MEMORANDUM

DATE: April 25, 2014

SUBJECT: OP Hearing Report 2 - ZC #13-14 (McMillan)
 First Stage and Consolidated PUD and Related Map Amendment
 Multifamily/Retail Building and Townhouses (Parcels 4 and 5)

Figure 1 – Parcels 4 and 5

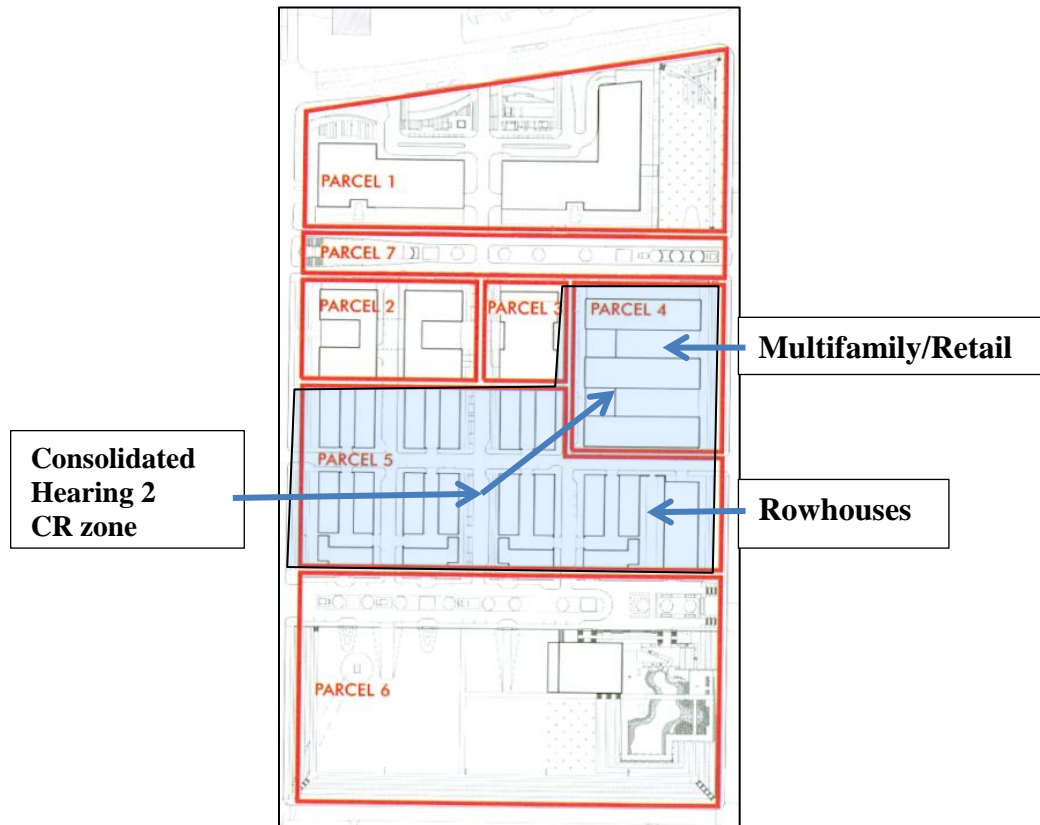
OP has advised the Applicant to more fully address the reasoning behind the reduction in the rear yards and court on units within Parcel 5.

The rear yard requirement for this zone is 12-feet and therefore a 12-foot front yard setback is required. This 12-foot front yard setback is provided on all the units where they are required. However, Buildings 1 to 8 and 10 to 18, provide only a 9-foot rear yard. The Applicant should provide an explanation as to the reasoning behind the need to reduce the rear yards. However, the reduction would not seem to negatively affect light and air to the units.

On Building 9, the applicant has requested flexibility to reduce the width of the open court to 9.5 feet where 10 feet is required. The applicant should provide a justification for the reduction.
